Re: File No. PL16-0056 – Applicant’s Review on Second Remand & Third-party review

Re: **Comments regarding:**
Lake Erie Groundwater Evaluation and third-party review

From Figure 4 of Northwest Groundwater Consultants. Northwest Groundwater Consultants assert that there is no groundwater water flow MW01 to the North Spring. The red line and red text notation has been added by me to show the steep groundwater gradient between MW01 and the North Spring.

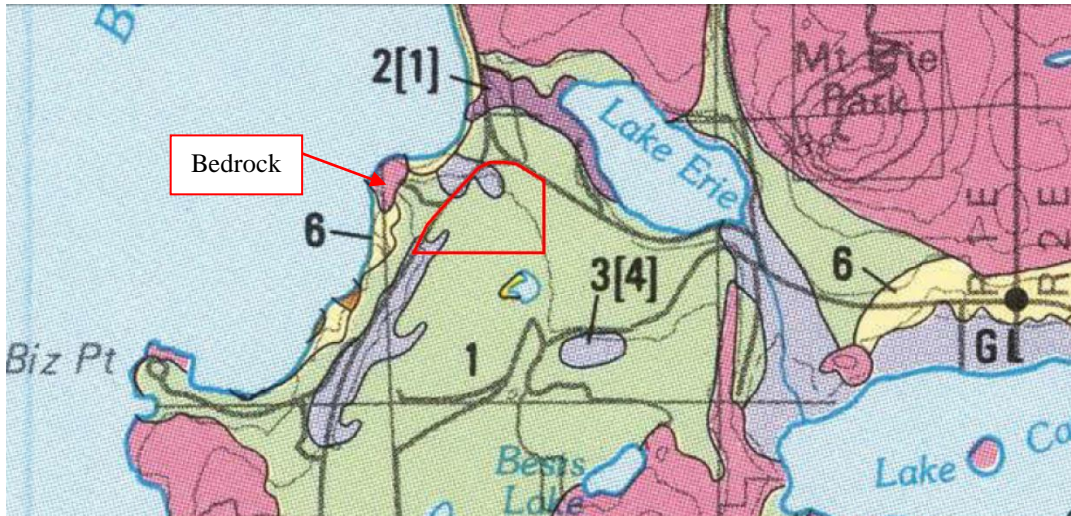
Groundwater elevations between the mine and the North Spring indicate that groundwater will flow predominantly towards the northwest from the mine site towards the shoreline bluff. As seen in the diagram below, the new groundwater elevation data provided by the installation of MW01, at the north end of the pit, confirms that there is a steep groundwater gradient from the mine area to the groundwater spring within that landslide area to the northwest of the mine. The groundwater elevation measured at MW01 was 191.4 feet while the groundwater elevation at North Spring was 169.3 feet, a full 22.1 feet lower at a distance of approximately 850 feet.

The NGC report claims that groundwater at North Spring located northwest of the proposed mine expansion is not hydrologically connected to the groundwater under the proposed mine or the existing mined area based on speculation that an intervening bedrock ridge redirects water flow and based on differences in water chemistry. As explained below, there is no evidence of a bedrock ridge and no difference in water chemistry that supports that claim.

Map showing unconsolidated deposits grouped on the basis of texture, Port Townsend 30' x 60' Quadrangle, Puget Sound region, Washington Miller and Pessel (1986), Pink = bedrock. Proposed mine is outlined in red.

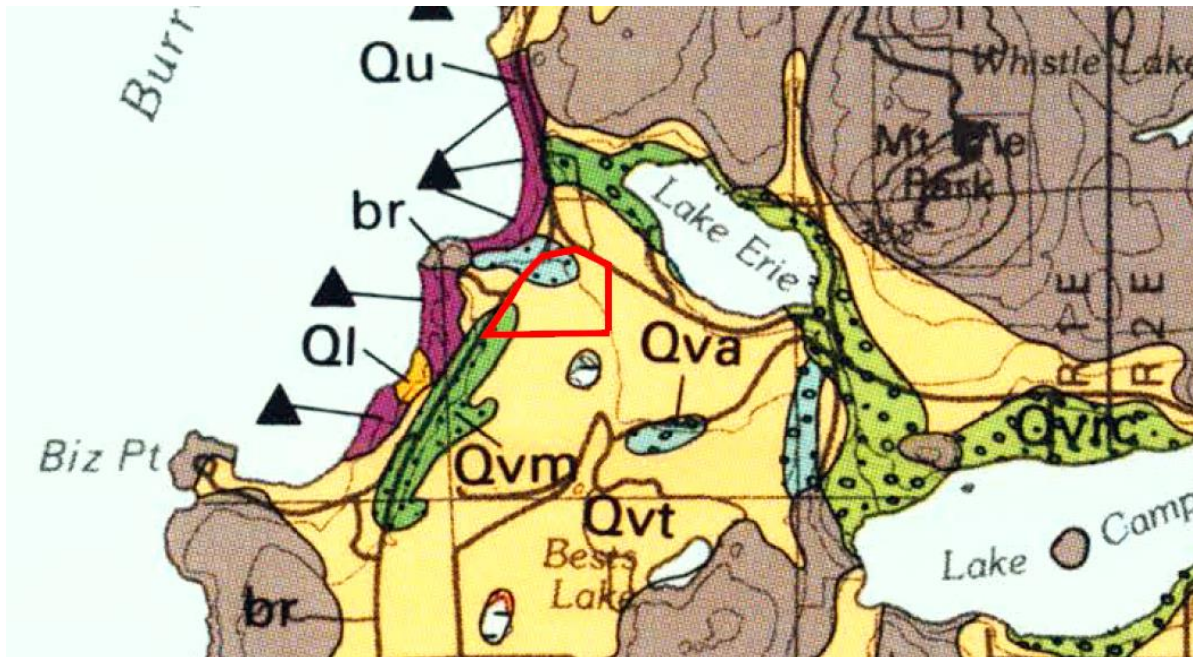
The report geology section appears to rely entirely on an on-line map from the Washington State Department of Natural Resources Geology Portal that is reproduced in the report as Figure 4. That map shows bedrock extending to the property. Unfortunately that map is incorrect in regards to the extent of bedrock. This map error should have been recognized by NGC. Direct observations should be standard geologic practice particularly given the assertion that there is a bedrock ridge deflecting groundwater flow. But NGC does not document any observations of bedrock or provide any evidence of bedrock deflecting groundwater flow to support the narrative that groundwater flows in a different direction than the one shown by the data.

At the beginning of the geology section on Page 3, NGC does state that “Detailed descriptions of the surficial and subsurface geology of the Site and vicinity are presented in a map completed by the U.S. Geological Survey (Miller and Pessel, 1986).” It should be noted that Miller and Pessel (1986) do not show bedrock at the site (see portion of map below).

Contrary to NGC's claim about the referenced map, the Miller and Pessel (1986) map does not provide detailed descriptions of the geology units. Pessel and others (1989) do provide detailed descriptions, but it appears NGC did not review the Pessel and others (1989) map. Pessel and others (1989) also do not show bedrock on the property; that map depicts the geology of the site and vicinity, as presented below.

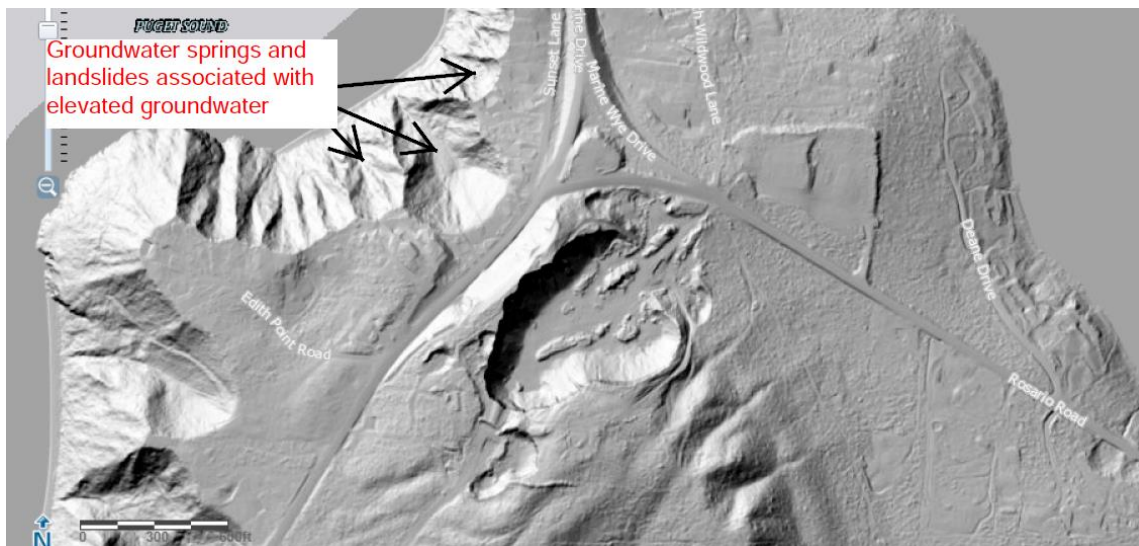
The well elevations were not surveyed. NGC stated that “Ground surface elevations were measured with the Trimble R1 (sub-meter precision) and corrected using 3DEP LiDAR digital elevation model from the USGS.” The Trimble R1 system can locate the sites with an accuracy within a meter (hence, the tern sub meter). The USGS indicates the newer elevation data used in the 3DEP model has an accuracy of 0.53 meters (about 1.75 feet) (<https://www.usgs.gov/faqs/what-vertical-accuracy-3d-elevation-program-3dep-dems>).

The elevation data in Table 3 is not as precise as implied and should include a +/- range to reflect the uncertainty or the uncertainty should have been discussed in the NGC report and should have been raised by Facet in their review. The +/- range is on the order of 2 to 4 feet. Given the low

difference in water levels between some of the wells this uncertainty is significant enough to affect the interpretation of water flow direction between some of the wells. That said the large difference between MW01 and the North Spring clearly shows that there is a steep groundwater gradient from MW01 to the North Spring.
